# City of Hurricane

## AGENDA

### OF A MEETING OF THE HURRICANE CITY PLANNING COMMISSION

Thursday, December 12, 2019

**HURRICANE VIEWS &  
ATLAS HURRICANE VILLAGE  
ENGINEERING**

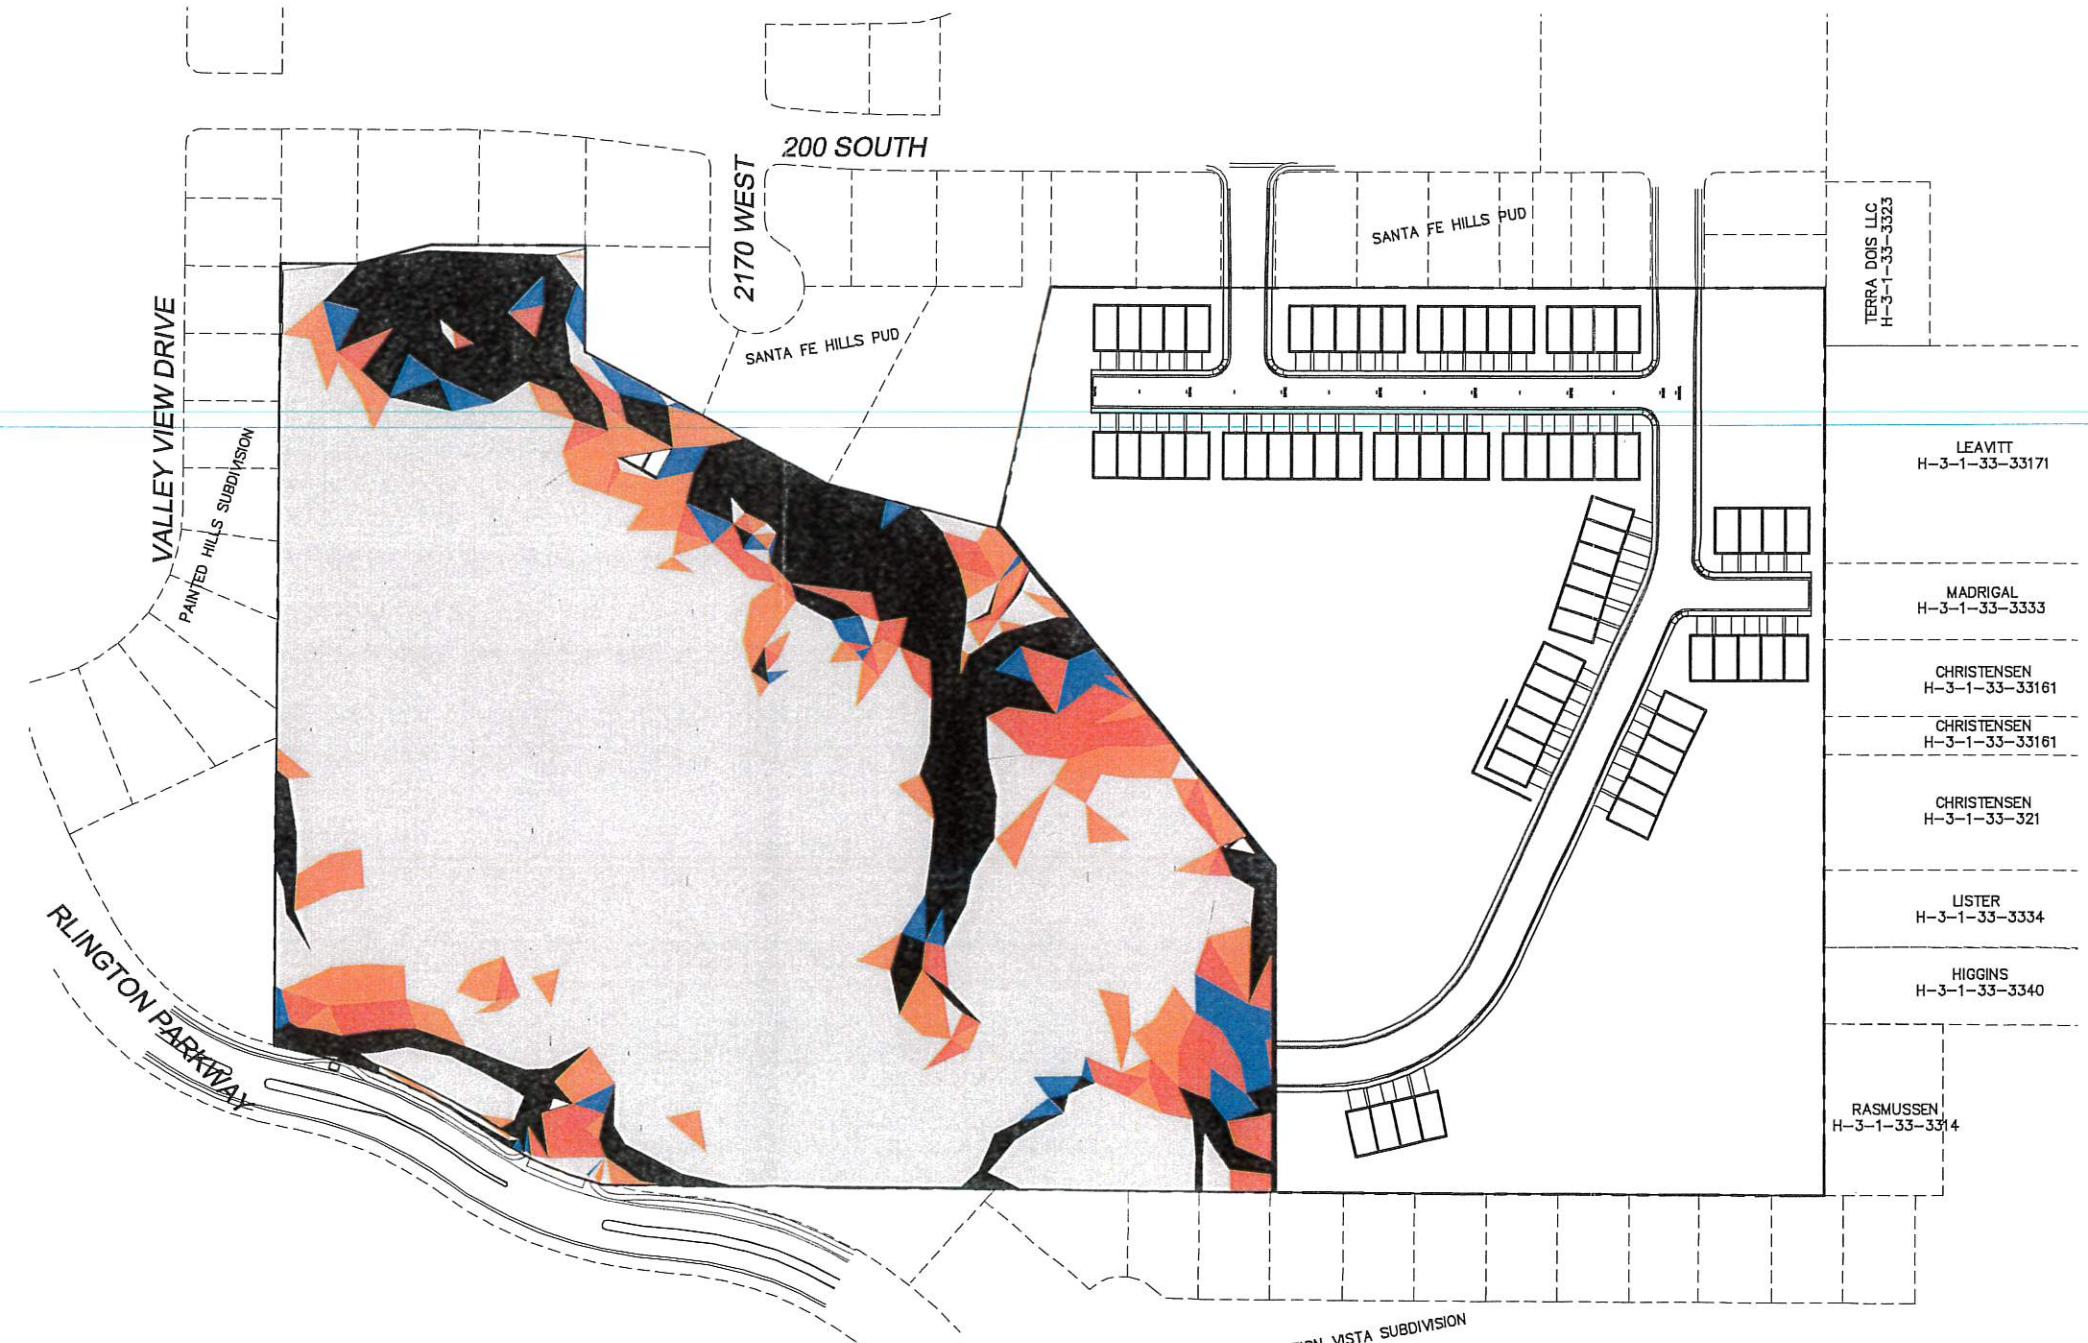
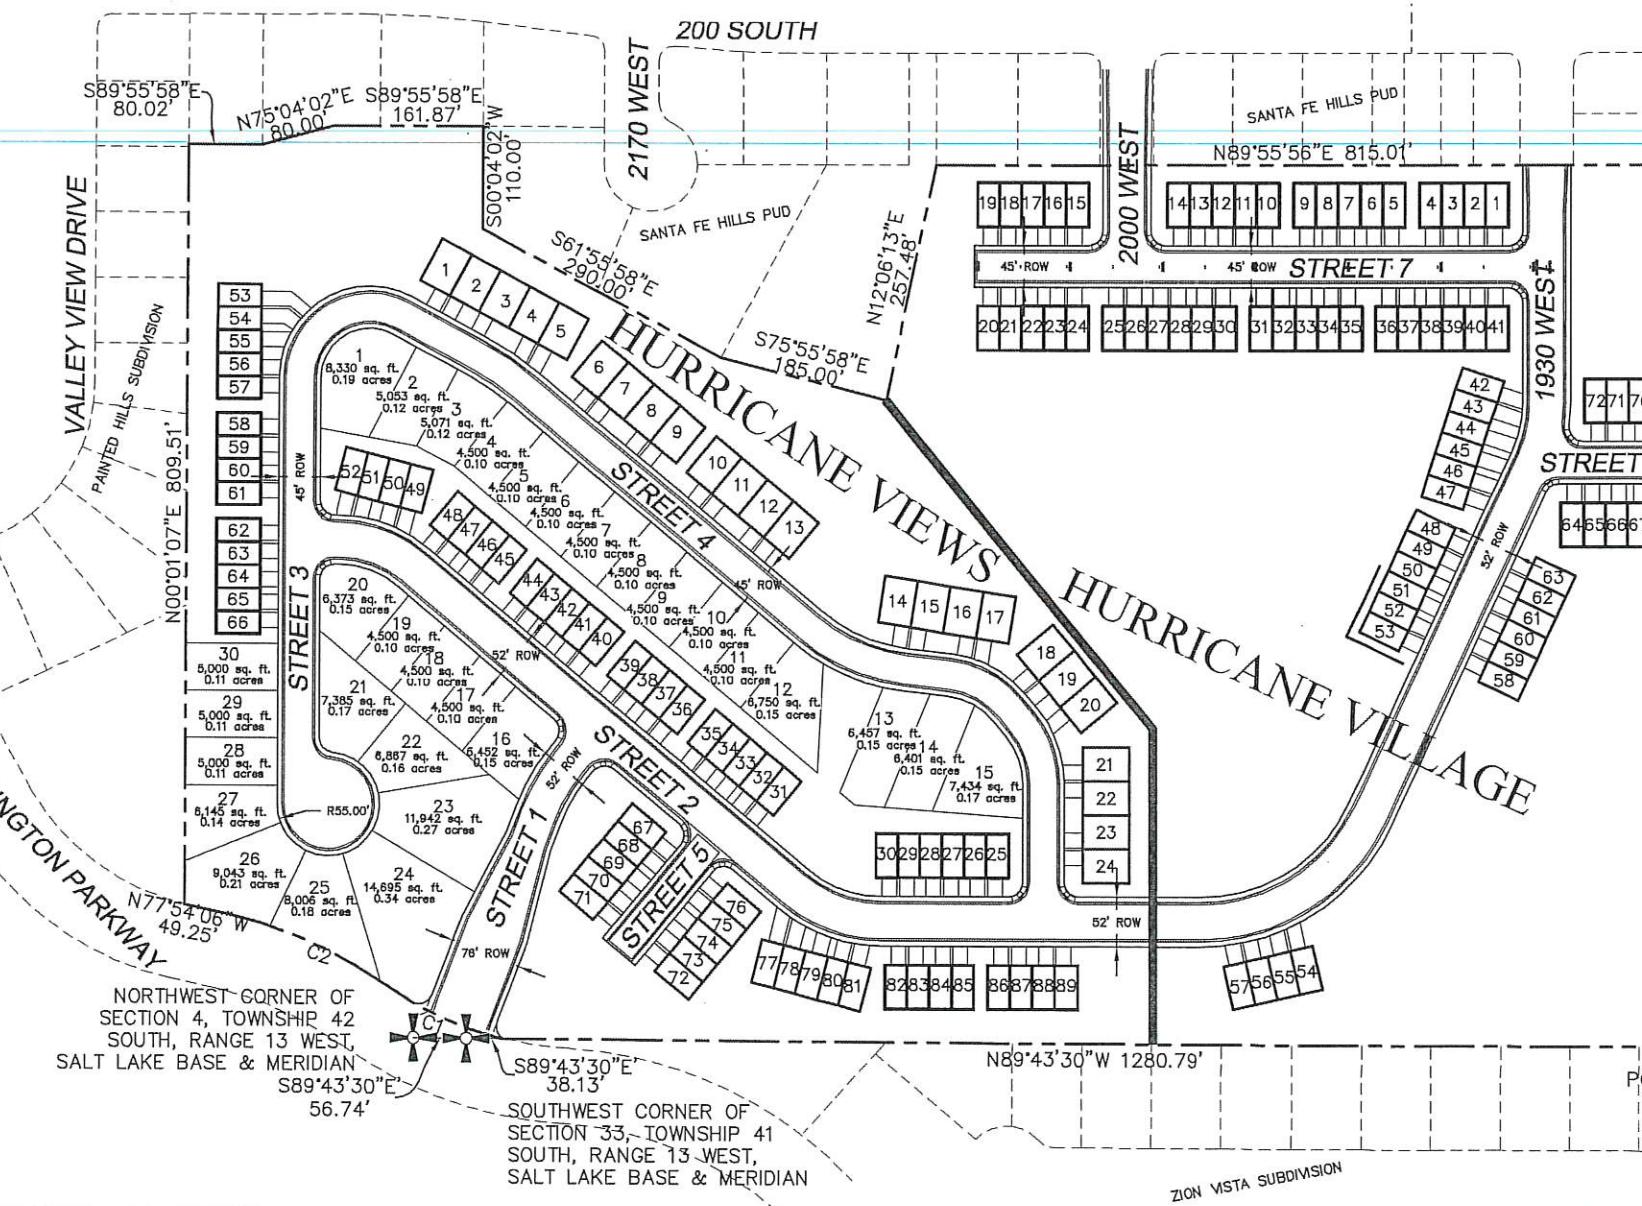
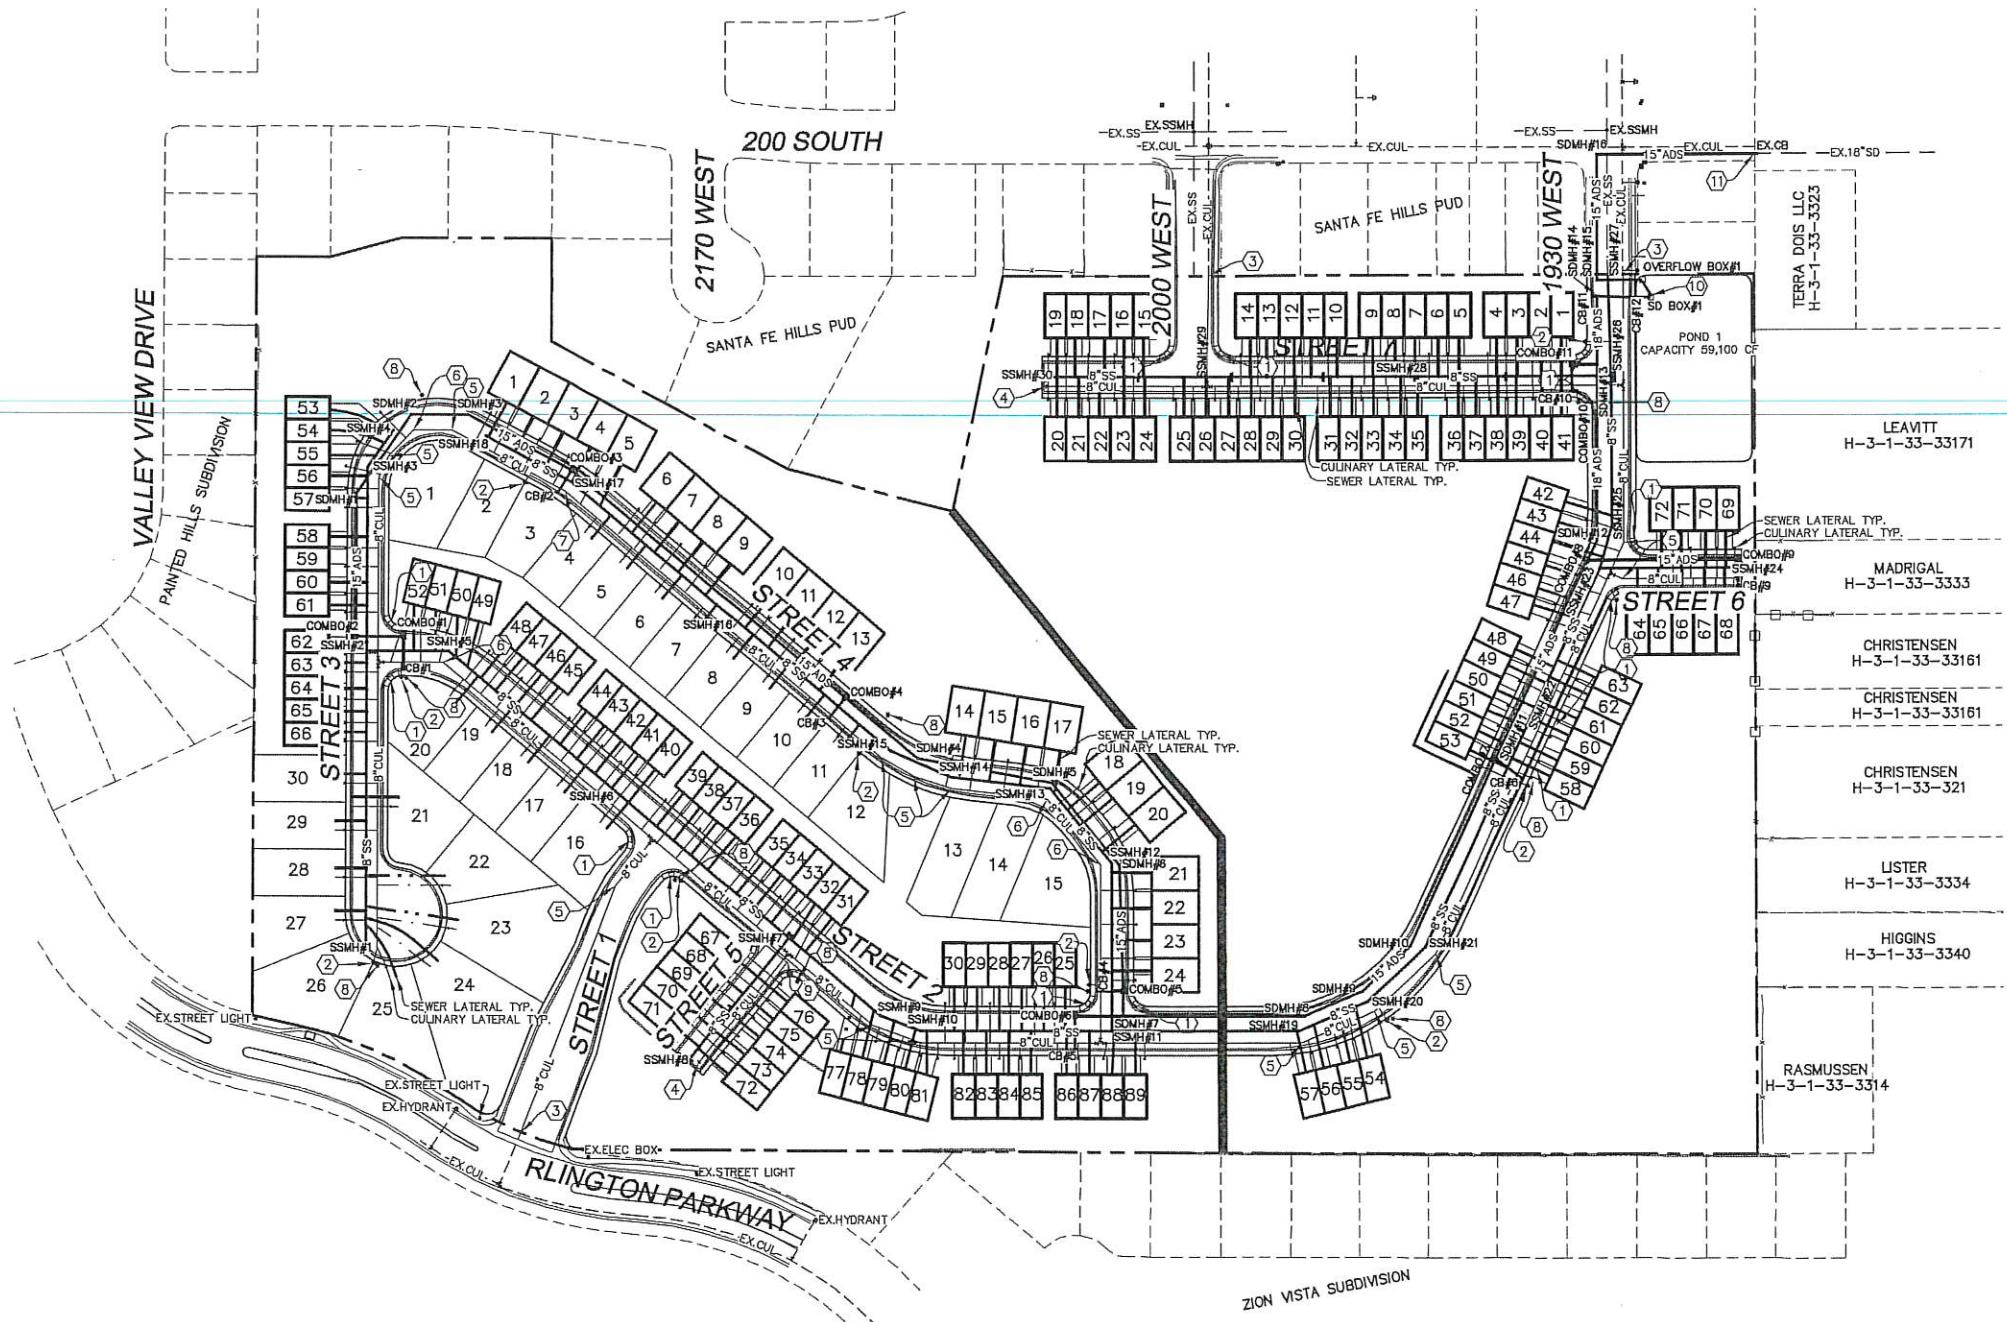
5. Length of the cul-de-sac on Street 3 does not appear to meet standards
6. Streets 6 and 7 are blunt dead ends with no turn around shown.
7. Drainage study is preliminary and final study will be required with construction drawings.
8. Phasing plan shows too many units on a single access in each phase. Fire Code and City access standards must be met.
9. It is not clear if the knuckle shown in Phase 3 meets Fire Code standards.
10. Design for natural gas must be submitted with construction drawings.
11. A traffic study may be required.

4. A reasonable distance has been provided between the single family homes in Painted Hills and Sante Fe Hills and the units in this project.
5. Lot sizes on the single family lots range from 11,942 sq. ft. to 4,500 sq. ft. This is a PDO so there are no minimum lot sizes. Grading plans will determine what portion of the lots will be usable. Final site plan should show a building envelope for review.

6. The following section of the code appears to still not be met, though an exception is allowed under 10-24-3G. *10-24-6: HILLSIDES AND RIDGE AREAS; GENERAL DEVELOPMENT STANDARDS: A. Unbuildable Slopes: Except as may be allowed by an exception as set forth in subsection 10-24-3G G. Exceptions: Exceptions to the provisions of this chapter may be granted by the city council upon recommendation from the planning commission when:*  
*1. An alternative solution is proposed for the protection of the sensitive land, based on sound and generally accepted engineering and land development principles, and said alternative will result in equal or better protection than development under the standards of this chapter; and is consistent with the purposes of this chapter. The alternative shall also be consistent with the general plan policies affecting sensitive lands; of this chapter, slopes of thirty percent (30%) or greater shall be undisturbed. Such areas shall be designated as a nonbuildable area if part of a residential lot, or at the election of the owner, these slopes may be offered to the city or a duly created nonprofit conservation organization. Slopes of thirty percent (30%) or greater, if included within a lot, shall not be considered as lot area contributing to the minimum area required in subsection B of this section.. The submitted plan shows areas of 30% or greater disturbed to create pads for Units 1,2, 6,7,8,12,13,14, 31,32, and 33. This is approximately 7% of the total number of townhome units. Commissioners should decide how to handle this section.*

7. It is clear the Sensitive Lands Code was written with single family lots in mind so consideration should be given to the different nature of a townhome project which results in less overall disturbance. This project leaves over 49% of the total property as common open space but without the grading plan it is unclear how much will be disturbed.

8. It appears the lot transfer calculations allowing bonuses for transferring lots off slopes and granting density bonuses might be a little generous for the developer, as many of the units are not completely off the 10% and greater slopes. The Planning Commission can determine if this is a reasonable application of this portion of the code.

**Recommendation:** Staff recommends the Planning Commission send a recommendation of approval to the City Council after making a determination on whether or not the units on the 30% slope meet any standards to be recommended for an exception. The motion should include language requiring compliance with all JUC requirements.
